Work Order ID 64640

Fixing Bracket

DART AEROSPACE LTD	Work Order:	64640
Description:	Part Number:	D4298-010
Inspection Dwg: 174398 Rev: 17		Page 1 of 1

SINGLE PILOT VFR CHART HOLDER, AW139

SIZE DWG. NO. 13939-1-290 SHT 6 OF 10

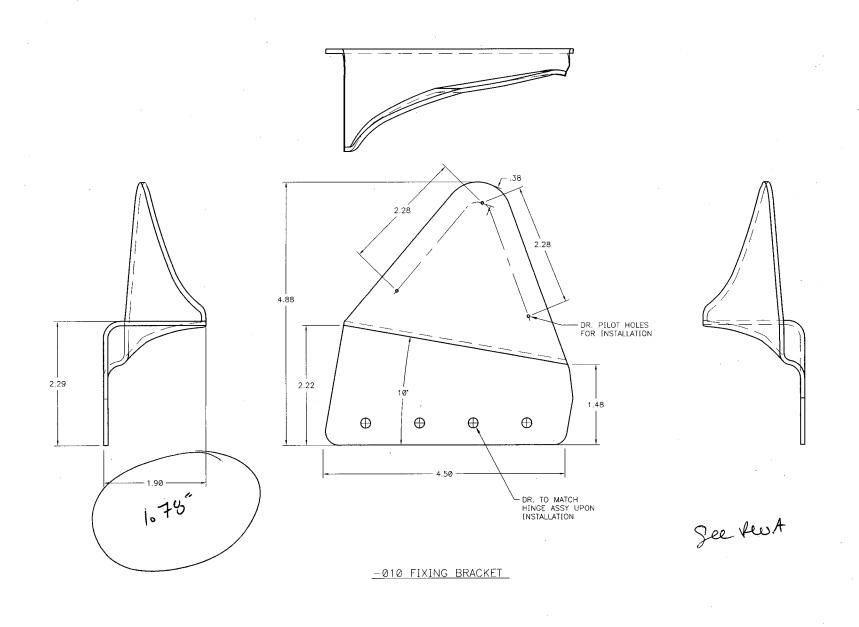
Part was trimmed too large. so it was re-trimmed and new FAI.

-010 FIXING BRACKET

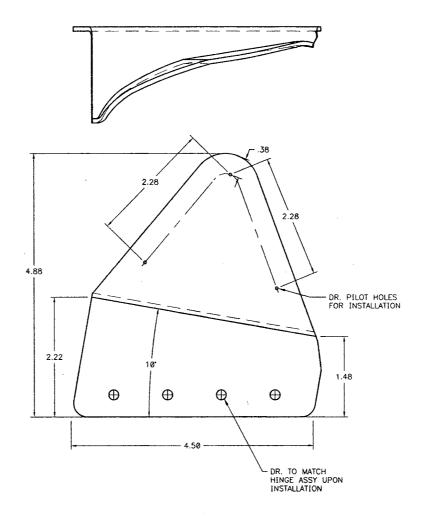
For the -010, this would make the chart holder about 1/8" closer to the instrument panel, but shouldn't affect its operation. If it does, perhaps we could add an 1/8" shim.

Hi David, couple of things here, on 13939-1-290-010 there's one dimension that we could not achieve, I attached a copy of the dwg with the non-conforming dimension please let me know if this will be acceptable, also for the -015 we did not have any 6061-T6... we have 6063-T5, would this mat'l be acceptable for the first unit.

We should be ok with this.

For the -015, I spoke with our machinist and he said 6063-T5 is okay to substitute.
